## **PRODUCT ENHANCEMENT BULLETIN**

Re: Low Leak Cabinets

Affected products: All Aspen Cased Evaporator Coils and Air Handlers

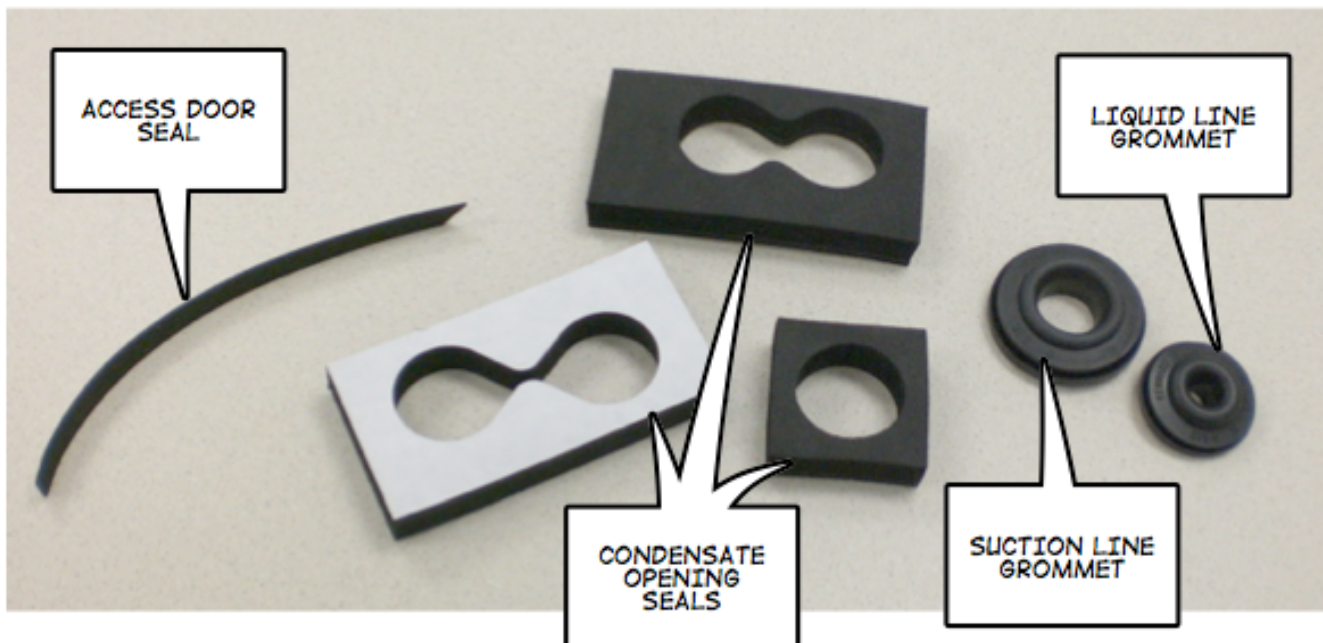
In response to this requirement, Aspen is redesigning the standard for its coil and air handler cabinets. Also, when less than 2% low leakage is required, Aspen will offer an option to cover this for a nominal extra charge. Both these changes, the design upgrade on standard product and the introduction of the < 2% option, will be effective 7/1/07.

The changes to the standard design will include 1) rubber grommets around the openings in the cabinet where the liquid and suction lines exit the cabinet (see fig.), and 2) a seal around the openings where the condensate drains exit the cabinet (see fig.).

The low leak option will incorporate these changes but will also include gasket material around all edges of the access door (see "access door seal" in fig.)
